MAHONING ROAD NE
 STA-0153-01.70

INTERSECTION DETAILS
GRACE AVENUE NE / INIANA AVENUE NE

REVISIONS	DATE	BY
CONSTRUCTION BIDDING SET	4/21/14	GEA
ADDENDUM NO. 1	5/7/14	GEA
STM SWR REVISIONS	10/1/14	GEA

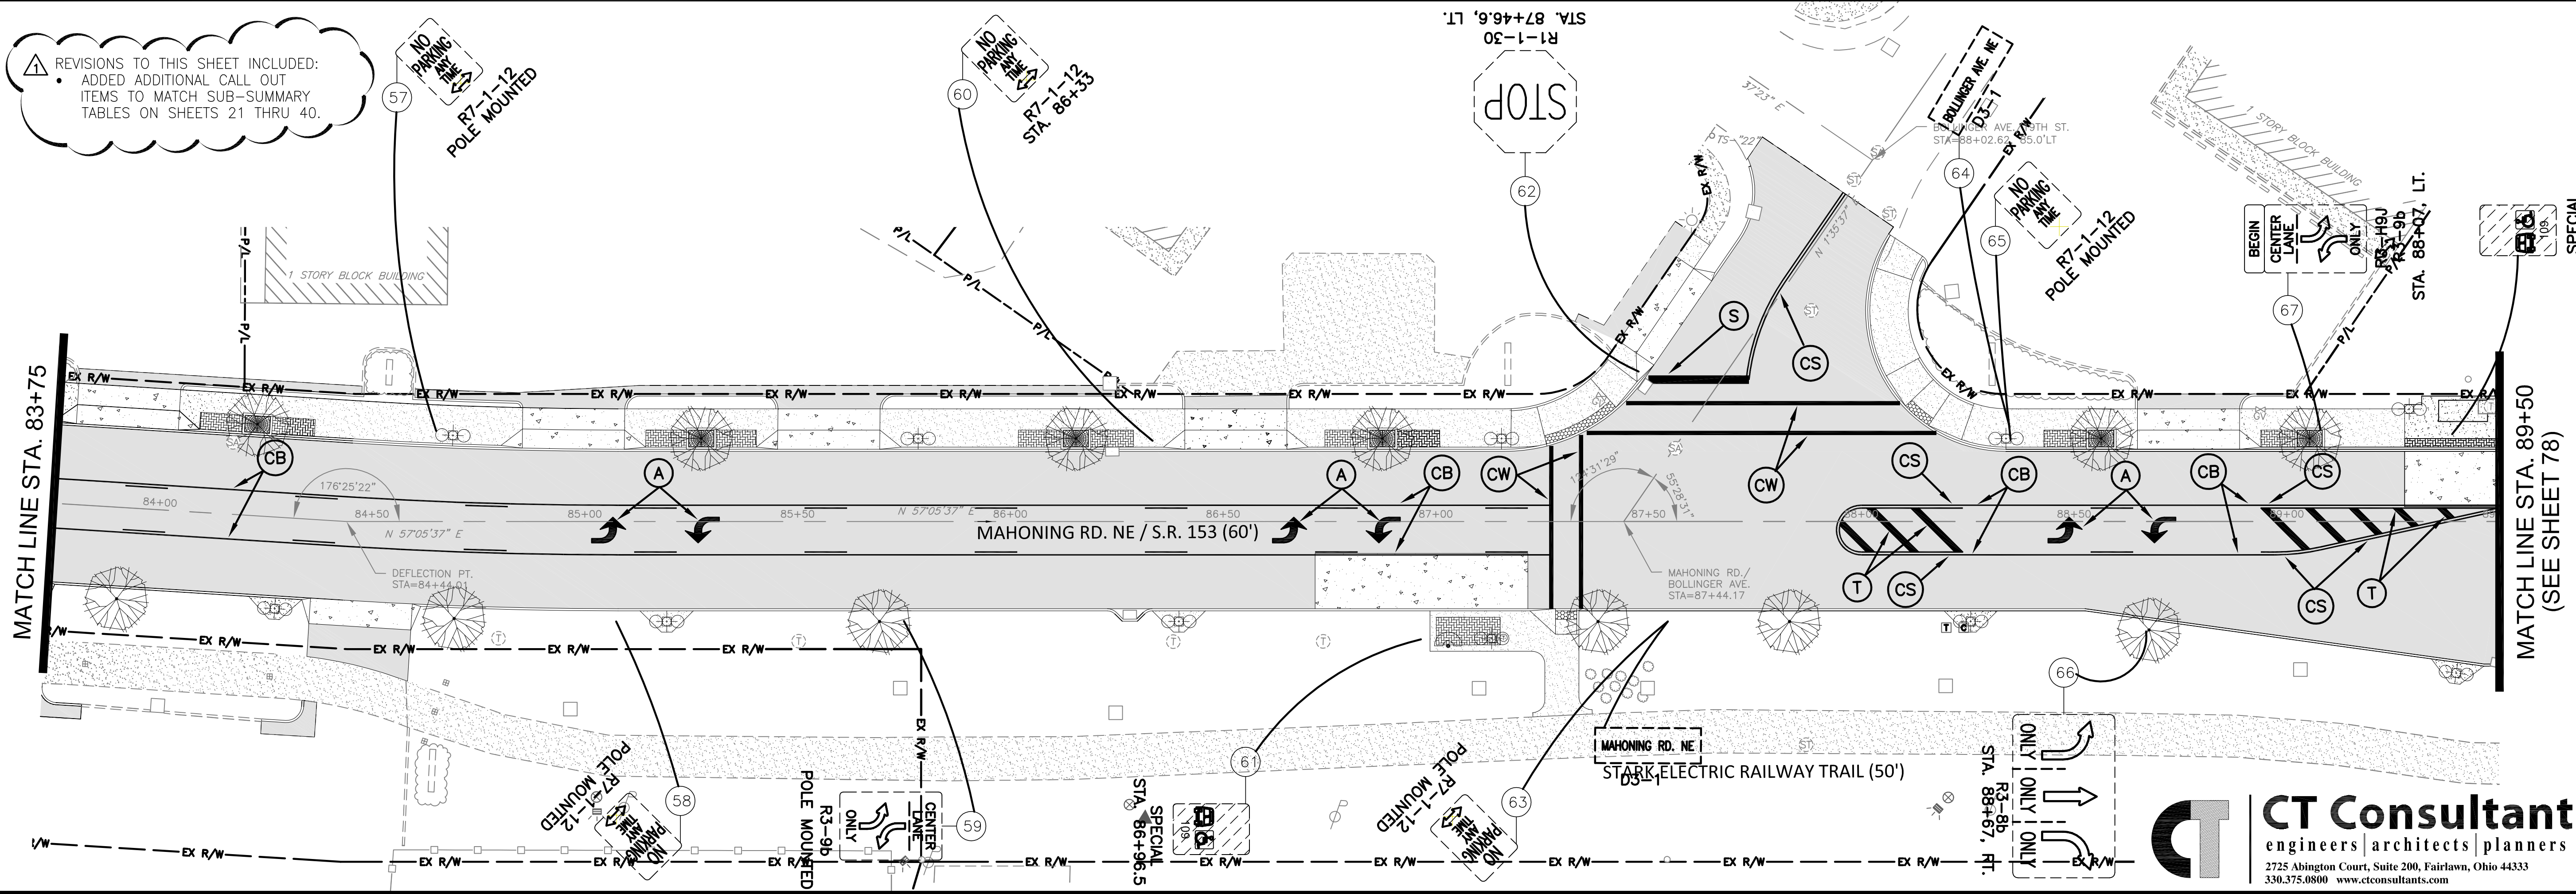
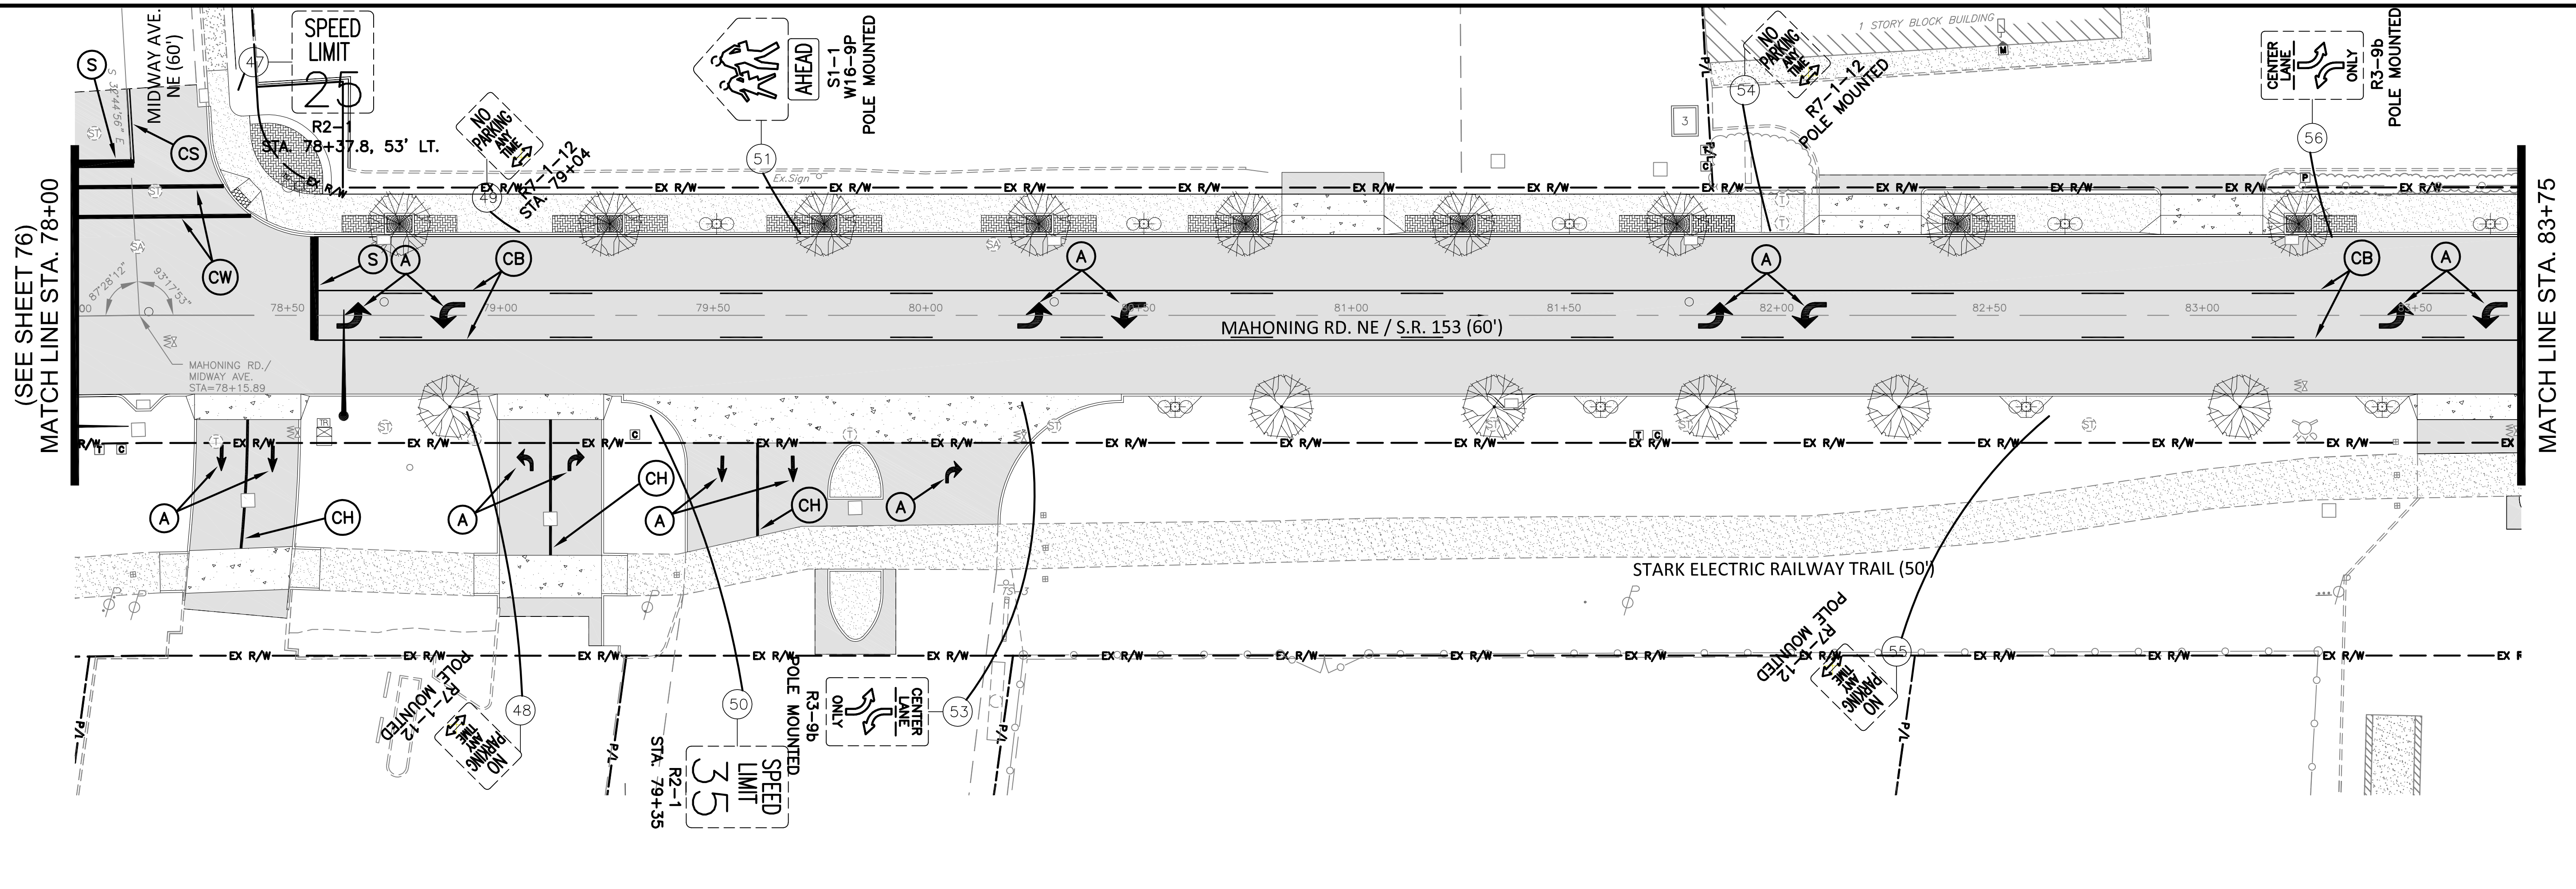
REVISIONS TO THIS SHEET INCLUDED:
 • ADDED ADDITIONAL CALL OUT ITEMS TO MATCH SUB-SUMMARY TABLES ON SHEETS 21 THRU 40.
